INITIAL FIRE SAFETY INSPECTION REPORT

ARRIVAL FASHION LIMITED (Bhaluka)

RSC ID: 24980

Date: 20-Dec-2023

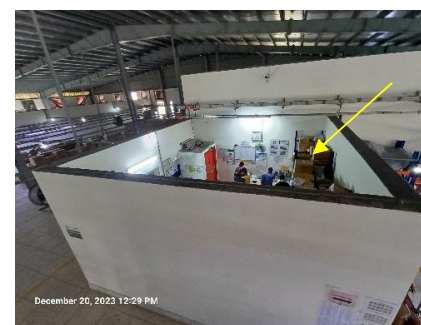
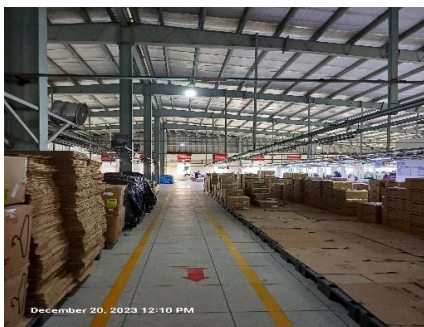
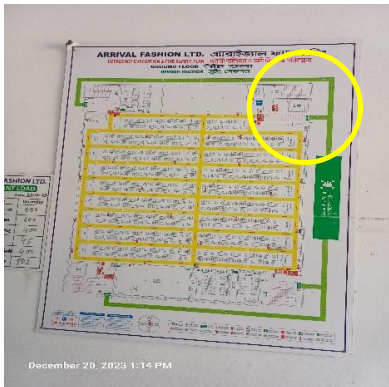
SI No.	Category	Findings	Required Action	Remediation Time Frame
1	Fire Rated Construction	The exit stairs are not separated from work areas and other spaces on each floor by fire rated construction. (Building-07 (Garments Building))	The exit stair enclosure shall be provided with a minimum 1-hr fire resistance rating for buildings with 3 or fewer stories and a minimum of 2-hr. fire resistance rating for buildings 4 or more stories. Provide 0.75 hr. fire rated door and seal all penetrations and openings by 1 hr. fire rated fire rated barrier construction for building with 3 or fewer stories. Provide 1.5 hr. fire rated door and seal all penetrations and openings by 2 hr. fire rated fire rated barrier construction for building with 4 or more stories. Ensure that the fire doors are self-closing and positive latching and that they are provided with fire exit (panic) hardware where serving production floors. If fire doors are required to be held open for functional reasons, provide automatic closing devices tied to the fire alarm system.	Within 3 months

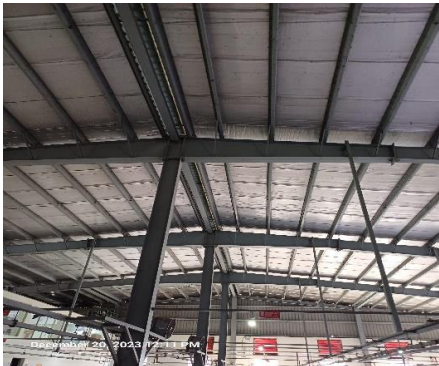
2	Fire Rated Construction	Storage area and basement floor discharges directly into exit stair enclosure. (Building-07 (Garments Building))	Openings from exit enclosure to storage area and basement spaces shall be provided with a vestibule with fire rated construction and openings. Ensure that the fire rating of the vestibule construction matches that of the exit stair enclosure.	Within 3 months
---	-------------------------	--	--	-----------------
